Subject: HARD TO SHIFT INTO 3RD GEAR	Bulletin No: 05-008/14
	Last Issued: 07/14/2014

2012-2013 Mazda3 (SKYACTIV 6 M/T)

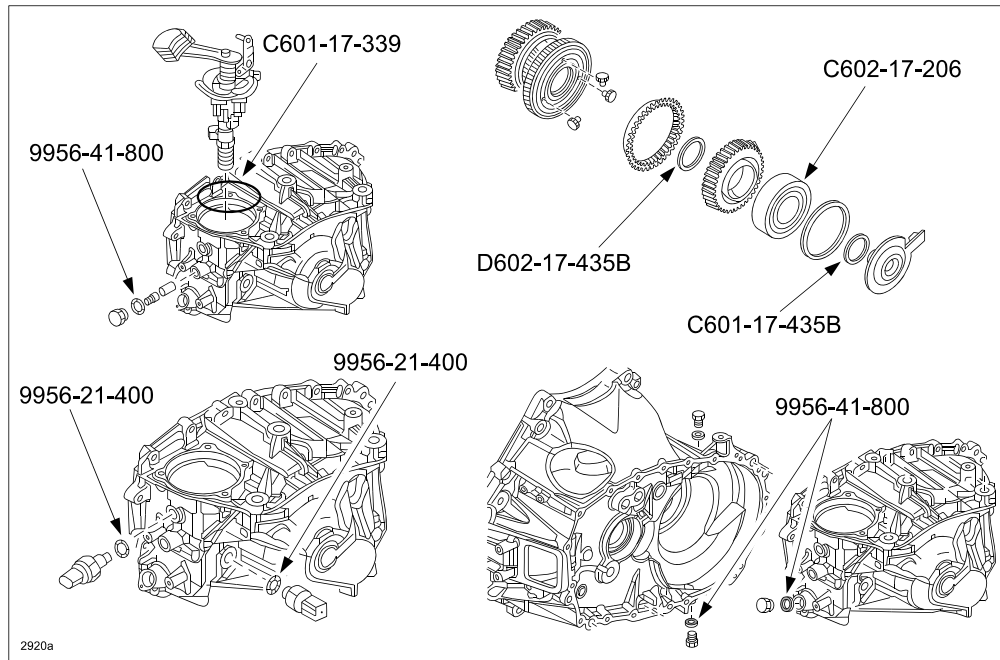
1. Verify customer concern.
2. Remove the transaxle. Refer to MS3 online instructions or the Workshop Manual section 05-15.
3. Replace the 3/4 clutch hub with a modified one and the 3rd gear with a new one (listed in the Parts Information). Refer to the C66M-R 6-speed SKYACTIV Manual Transaxle Workshop Manual.

This is caused by the friction coefficient between the 3/4 clutch hub and the sleeve increasing. A surface treatment has now been added to the 3/4 clutch hub to decrease the friction coefficient.
